Type of Submission: Notice of Intent	Type of Action: Plug and Abandonment
Date Sundry Submitted: 01/23/2023	Time Sundry Submitted: 06:02
Date proposed operation will begin: 02/07/2023

Procedure Description: Hilcorp Energy Company requests permission to P&A the subject well per the attached procedures, current and proposed wellbore schematics. The Pre-Disturbance Site Visit was not conducted as surface is Forest. A closed loop system will be used.

HILCORP ENERGY COMPANY
San Juan 27-4 Unit 119
NOTICE OF INTENT TO PERMANENTLY ABANDON

CONDITIONS OF APPROVAL

San Juan 27-4 Unit 119 - CURRENT WELLBORE SCHEMATIC

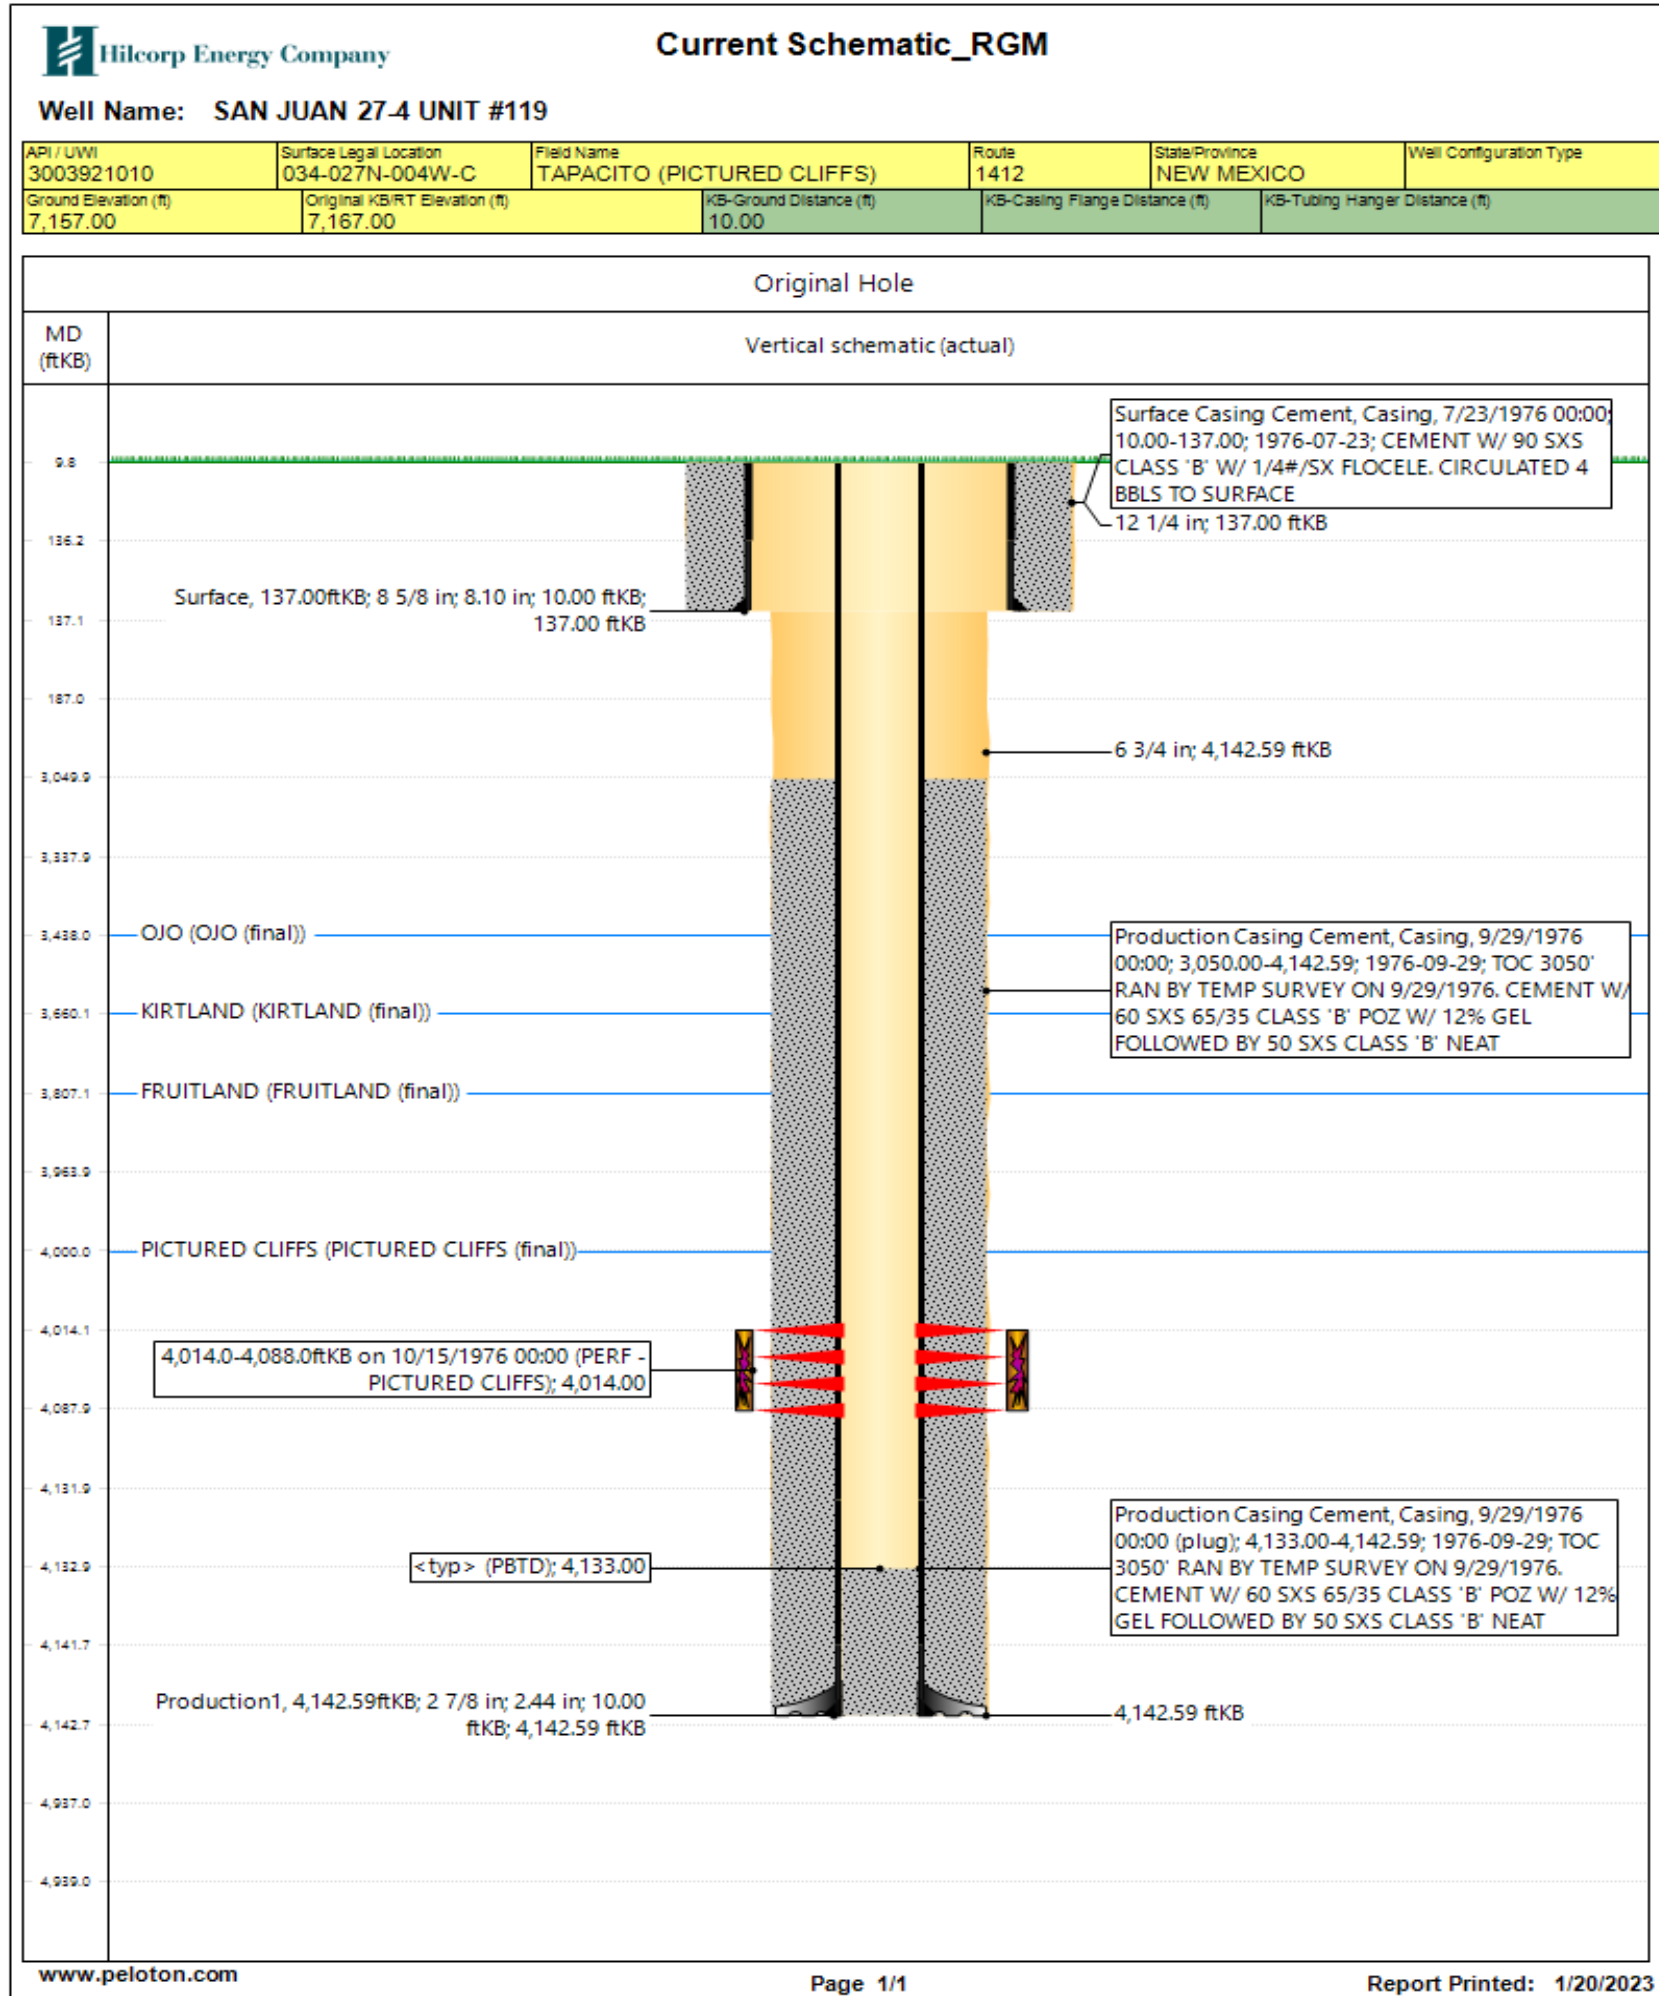
You are also required to place cement excesses per 4.2 and 4.4 of the attached General Requirements.

Created By	Condition	Condition Date
kpickford	Add a Plug 2270-2170 to cover the Nacimiento top @ 2220'.	2/3/2023
kpickford	CBL required	2/3/2023
kpickford	Notify NMOCD 24 Hours Prior to beginning operations	2/3/2023
kpickford	Adhere to BLM approved COAs and plugs. See BLM COAs and GEO report.	2/3/2023
